From:
Sent: 11 January 2023 12:12
To:
Cc:
Subject: SMD/2021/0491 - Land off Tenford Lane - LLFA Response (Rev 11)

Thank you for reconsulting us on the RM application SMD/2021/0491 – Land off Tenford Lane.

Staffordshire County Council Flood Risk Management Position

Figure 13.4 Plan view of **infiltration basin**

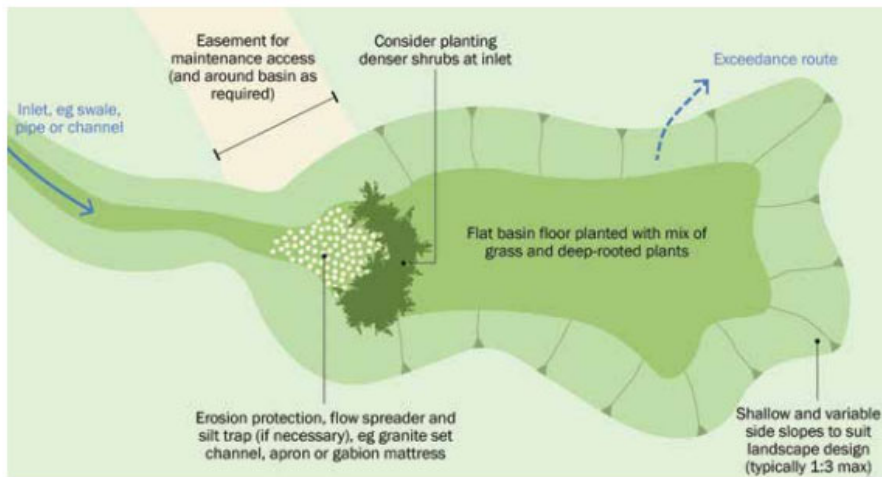
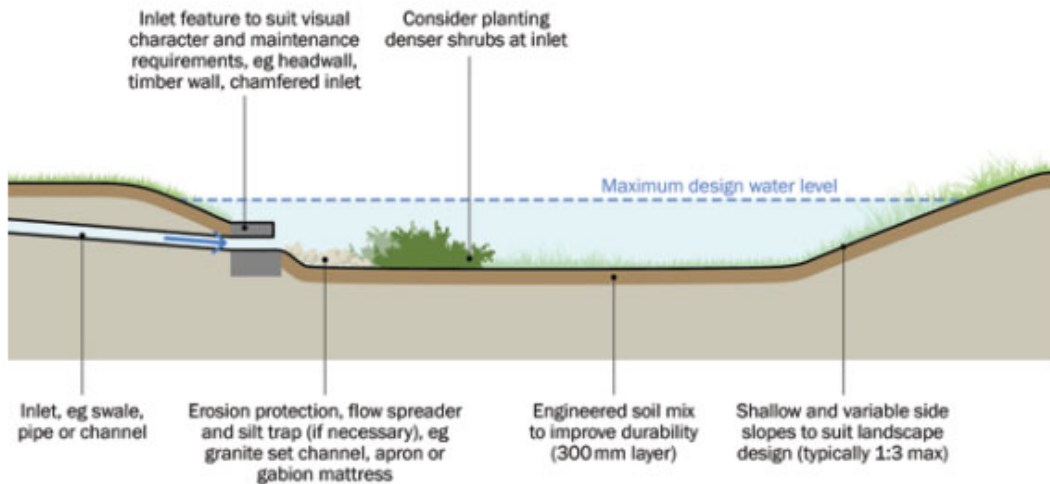
- Need to see landscaping plans for the swale to ensure infiltration potential is
optimised with planting and to show how erosion will be prevented.
Landscaping scheme has already been provided with planting scheme, but
please see this attached again.
We're looking for something like this example in the SuDS Manual:
Please see attachment LDS517(B)-LS, LDS517-01 RevB and LDS517-02 Rev B
attached

Figure 13.4 Plan view of **infiltration basin**

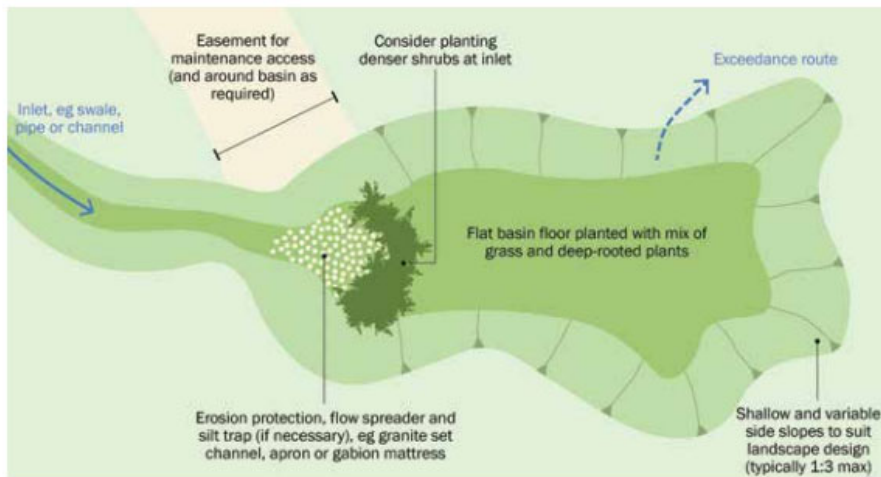
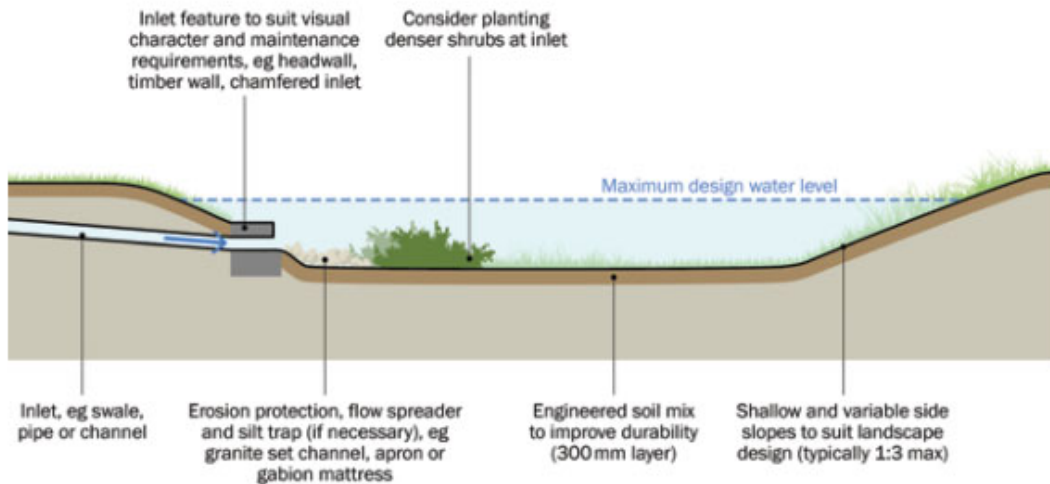
- How will erosion be prevented in Basin 3 and how will pre-treatment be provided given there is no corresponding swale associated with this basin? Slopes are limited to a max gradient of 1/3 to reduce the potential of landslips/ suitable vegetation to be provided to improve structural stability. While we accept that some of the water from the private network will be filtered through the porous paving, the remaining roof water, requires (as per the SuDS Manual) a minimum of catch pits for pre-treatment.
- Need to see landscaping plans for the swale to ensure infiltration potential is optimised with planting and to show how erosion will be prevented. Landscaping scheme has already been provided with planting scheme, but please see this attached again. We're looking for something like this example in the SuDS Manual:
